BID
ADDENDUM #03

FOR THE
RENOVATION TO MAIN
TELECOMMUNICATIONS
ROOM

AT
WEST VALLEY COLLEGE

Bid #2-1415

Sketch **MSK-03**
MECHANICAL SECTION 3

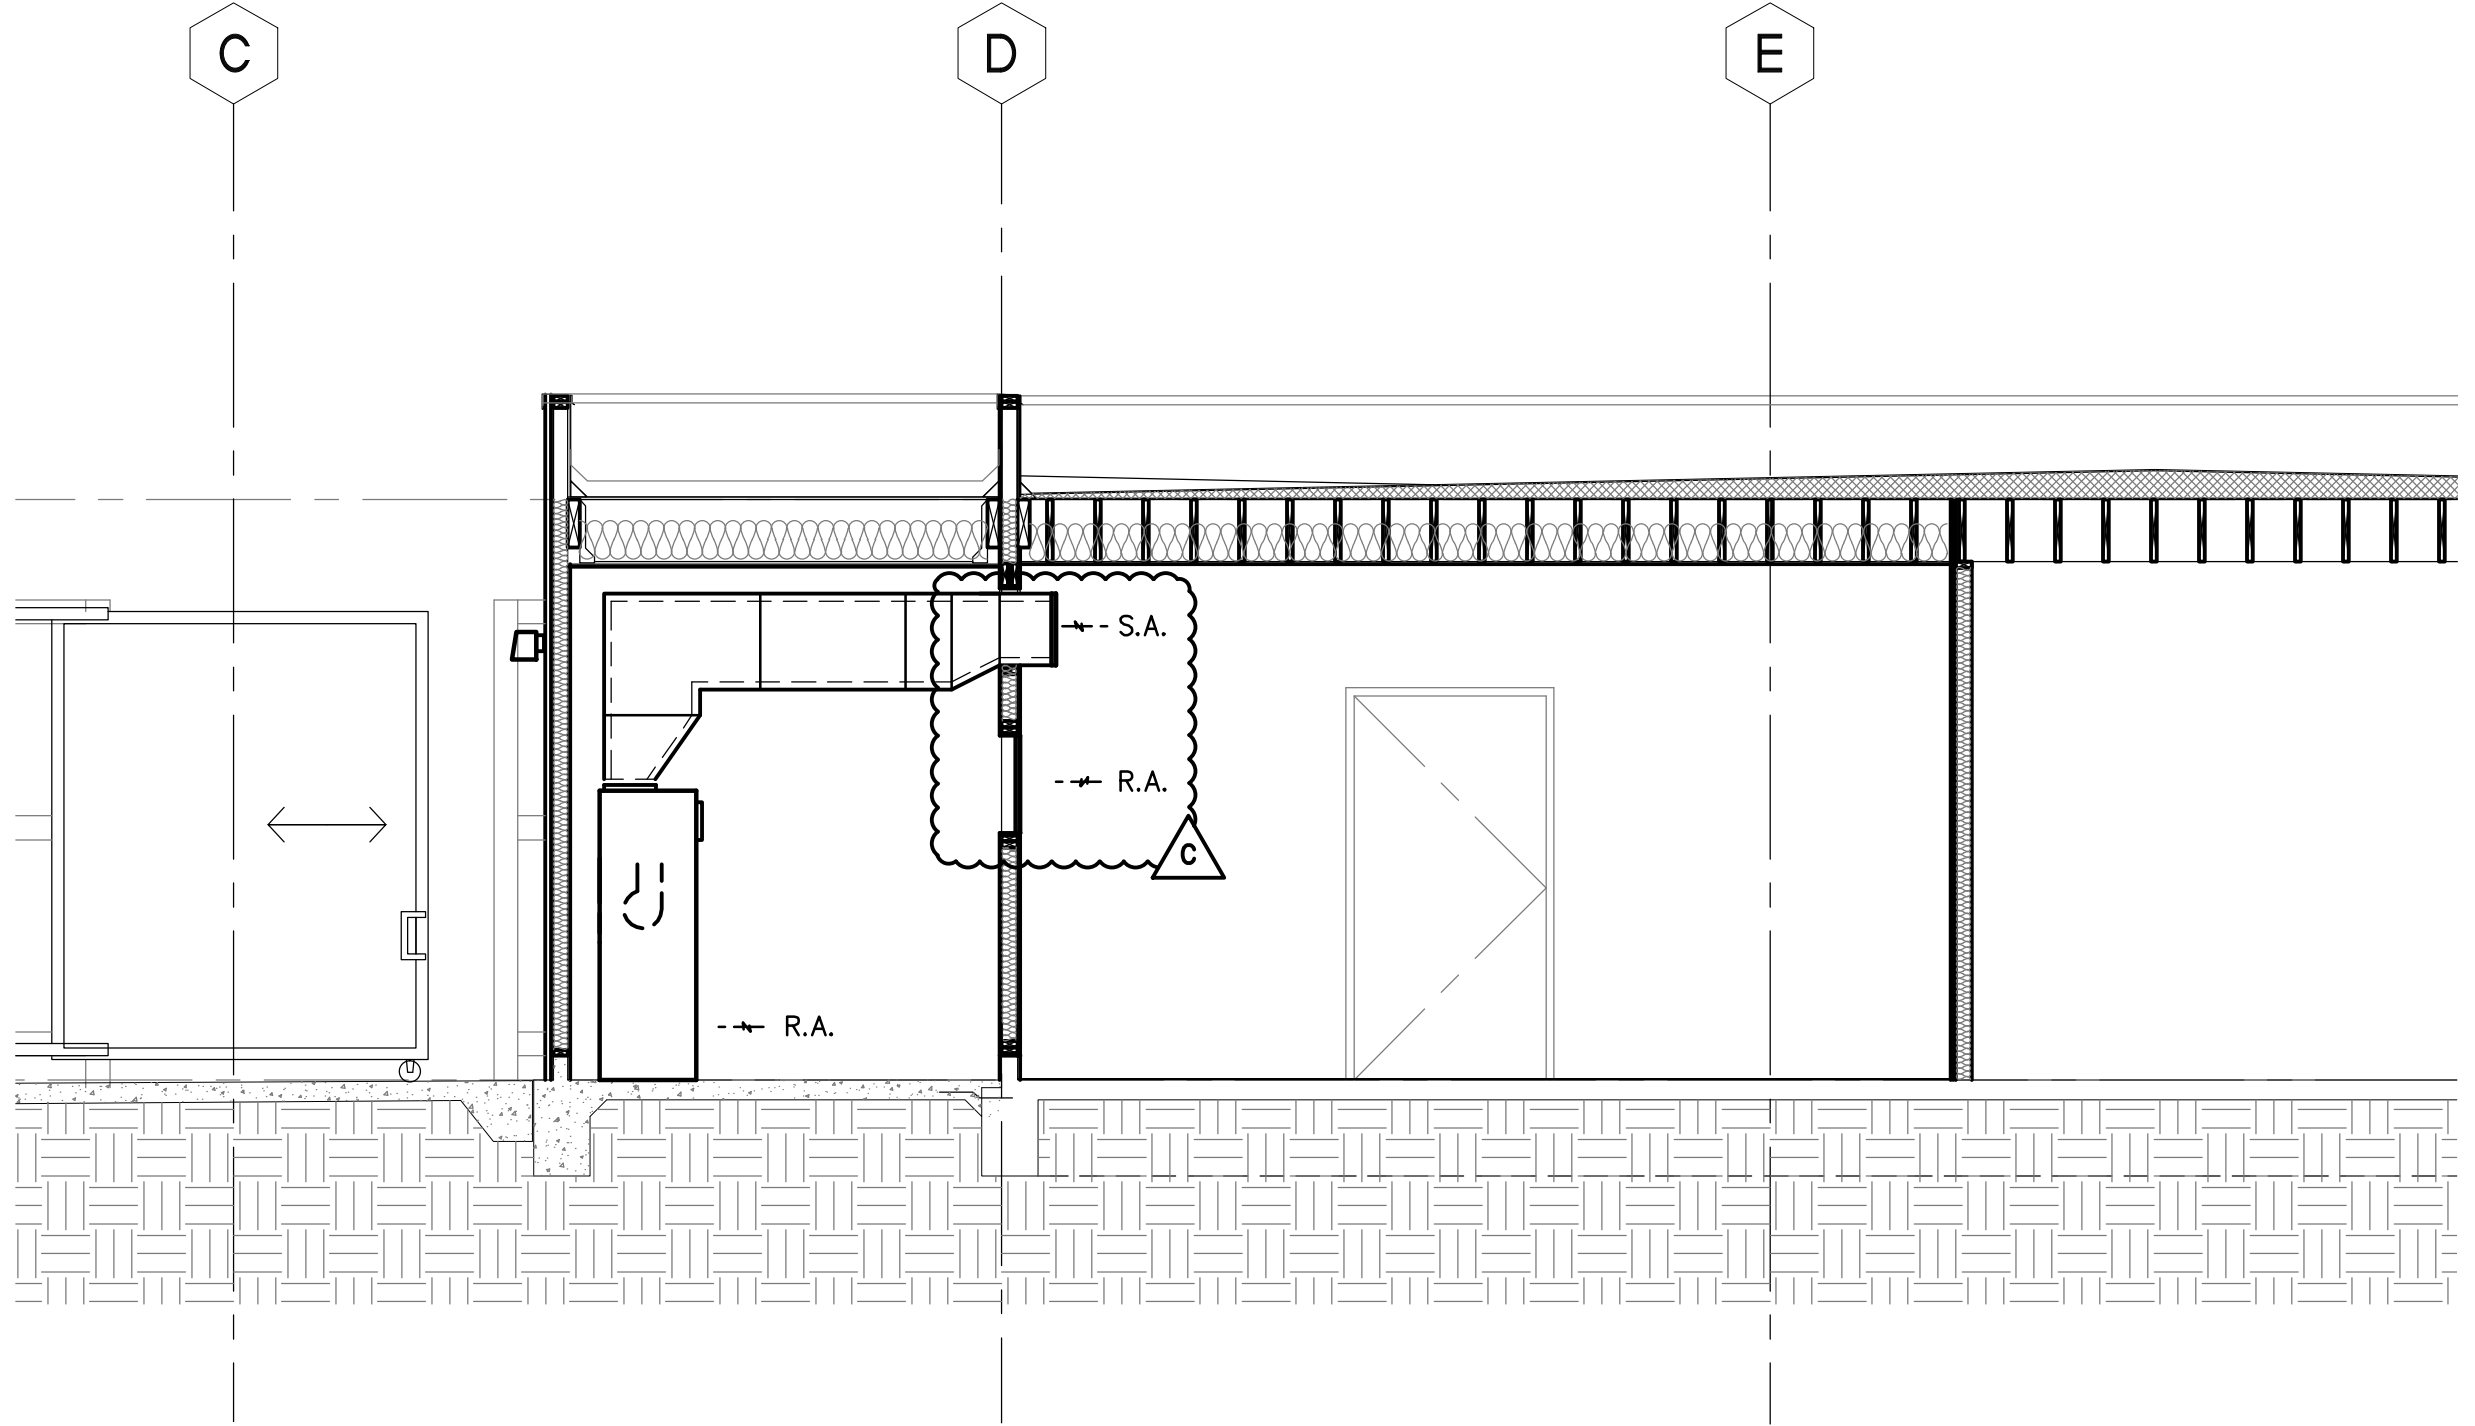
- ITEM NO. 5** Sketch revision MSK-03 of 03/M3.01
1. Supply air grille extended 1'-0" from shear wall.
 2. Grilles moved per new locations noted in Mechanical Section 2.

Sketch
SK-FP1.0

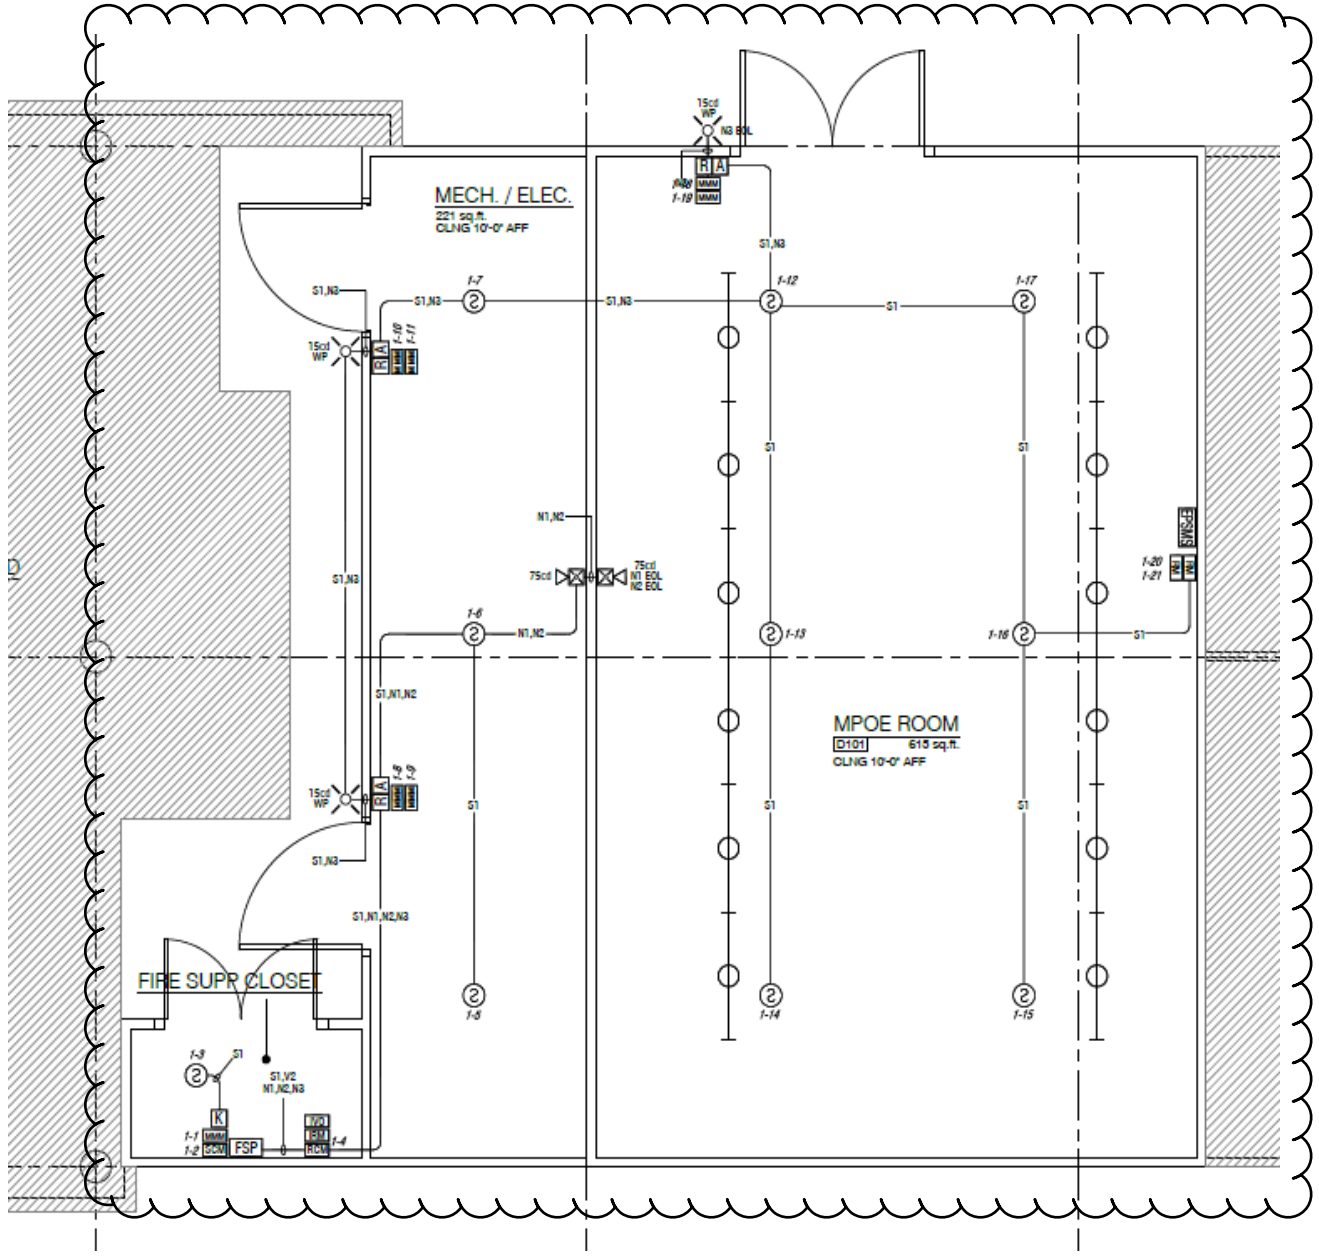
- ITEM NO. 6** Sketch revision SK-EP01 of EP1.0. Provided missing plan.
- ITEM NO. 7** Sketch revision SK-FP01 of FP1.0. Provided missing plan.
- ITEM NO. 8** Sketch revision SKE-01 of E1.01. Revised conduit routing based on as-built information.

Sketch	Revision
SKE-02	Addendum C
Job. No. 13122.10	Description
Reference E1.01	S□□□□□1.01
Date 2/4/15	□□R□□□□□N
Scale NTS

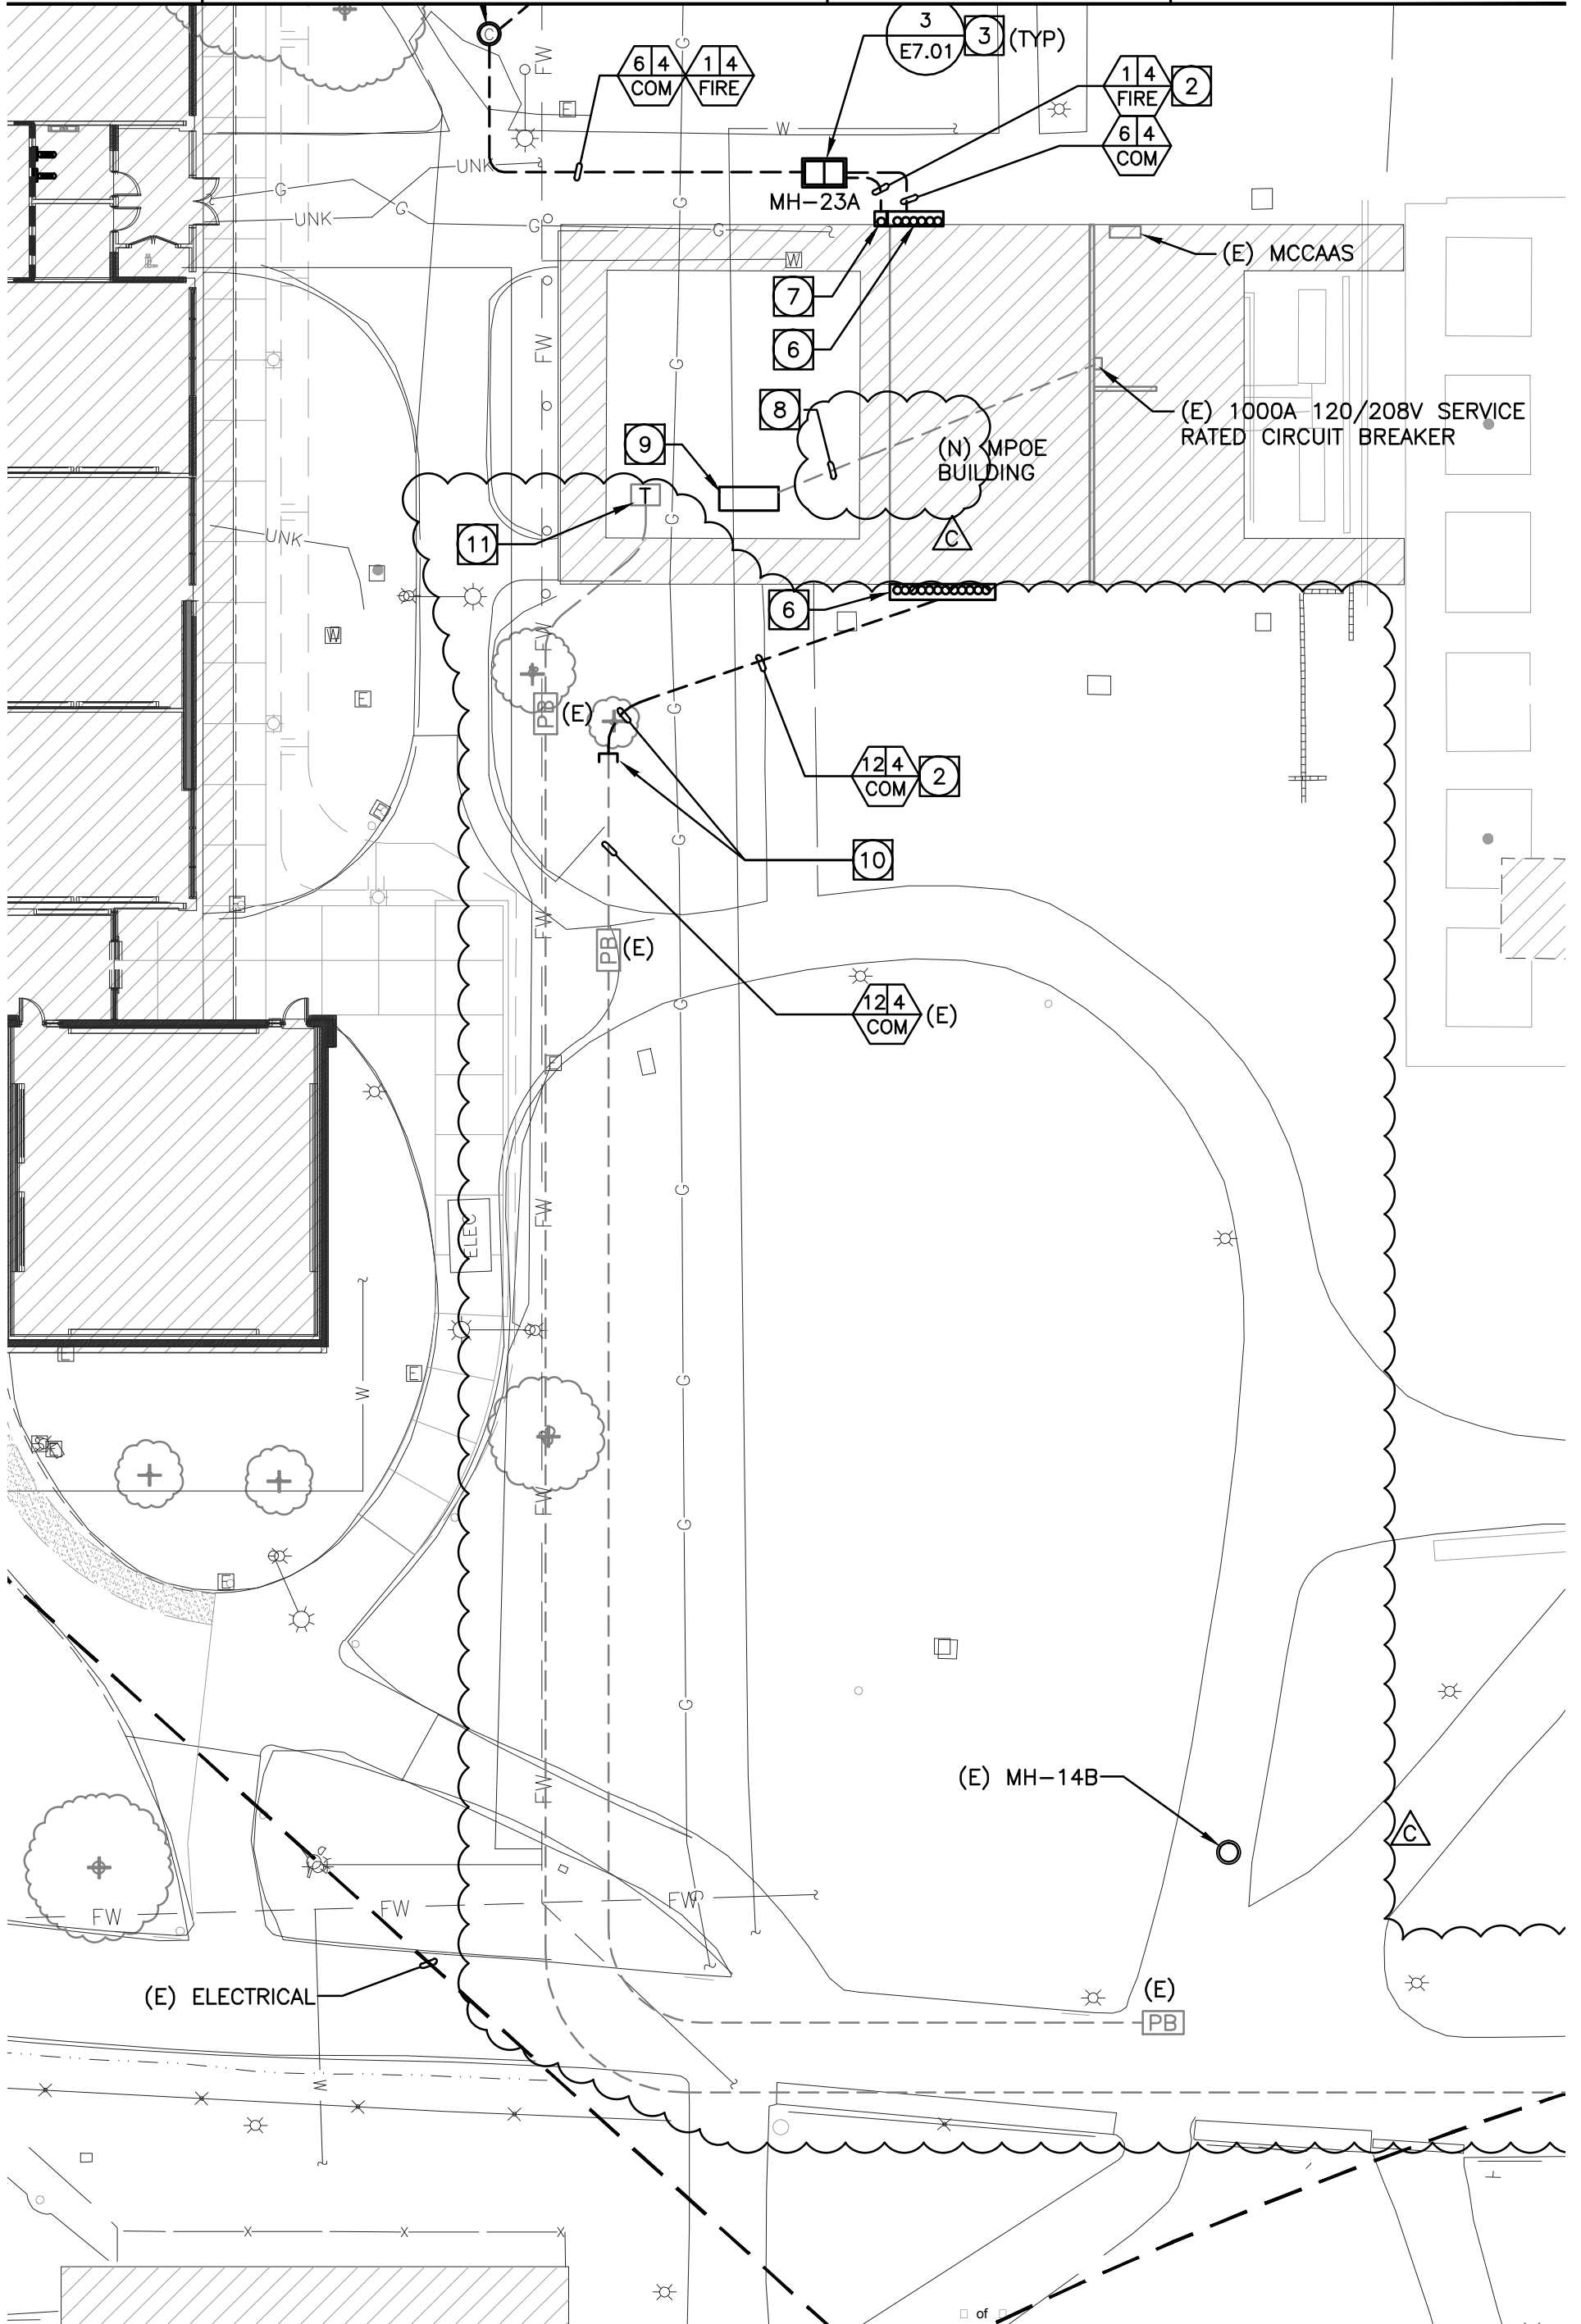
- ITEM NO. 9** Sketch revision SKE-02 of E1.01. Revised conduit routing based on as-built information.
- ITEM NO. 10** Sketch revision SKE-03 of FP1.0. Revised plan notes based on as-built information.
